▶ **FILE #:** 6-J-14-UR

▶ **APPLICANT:** AMERICAN CAMPUS COMMUNITIES

▶ **PROPOSED USE:** Over flow parking lot

**6-J-14-UR
USE ON REVIEW**

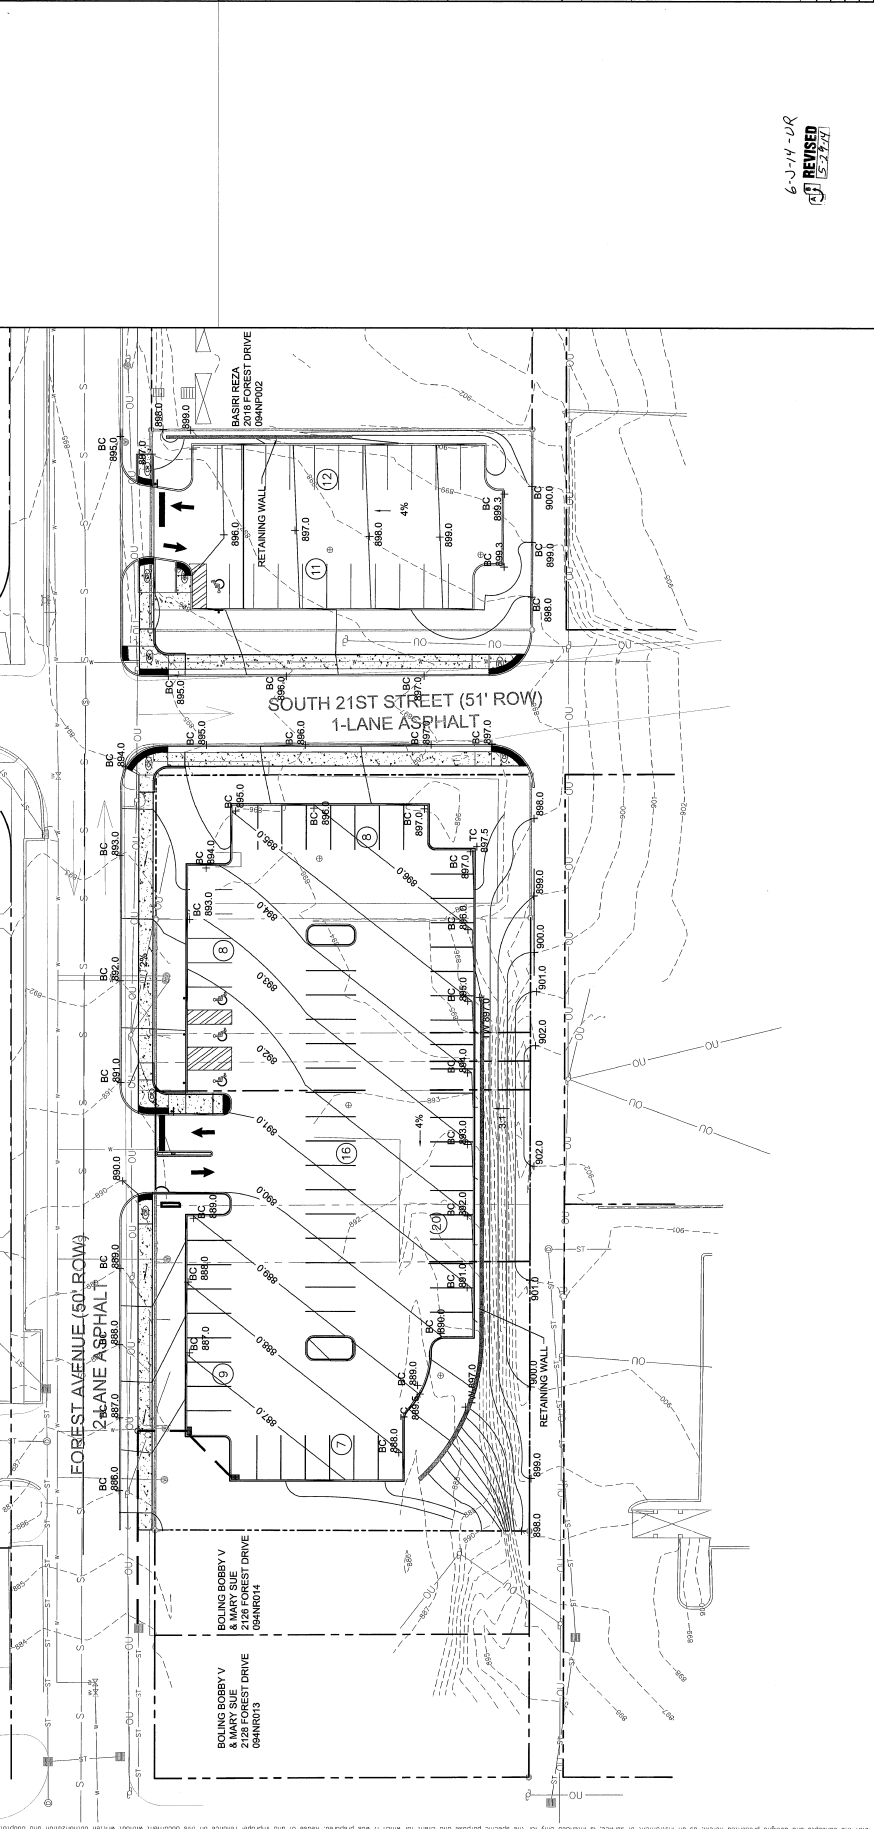
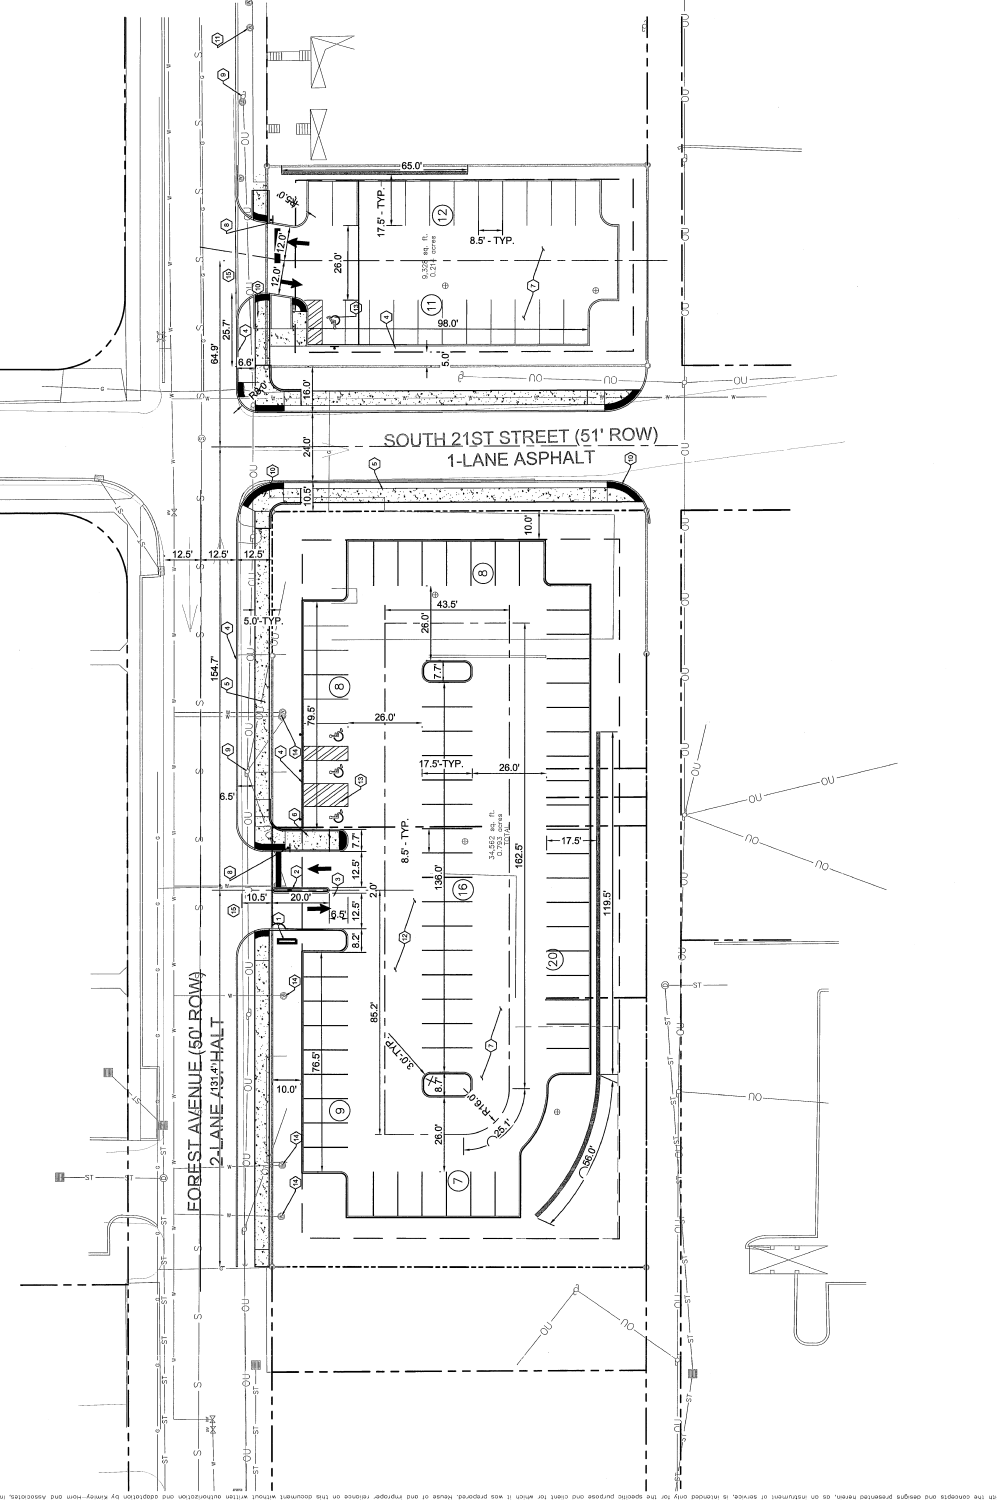
▶ **APPROVE the request for an overflow parking lot as shown on the site plan subject to 3 conditions**

1. Limiting the use of the parking lot to the residents and guests of the apartment project being developed by this same applicant at 2308 Forest Av. (094OD02001)
2. Meeting all applicable requirements of the Knoxville Zoning Ordinance
3. Extending the sidewalk on Forest Ave. to the eastern property boundary of the property located at 2022

Forest Ave. (094NP001)

4. Provision of handicap accessible as required by the Knoxville Engineering Dept.
5. Meeting all stormwater and water quality controls as required by the Knoxville Engineering Dept.
6. Meeting all other applicable requirements of the Knoxville Engineering Dept.
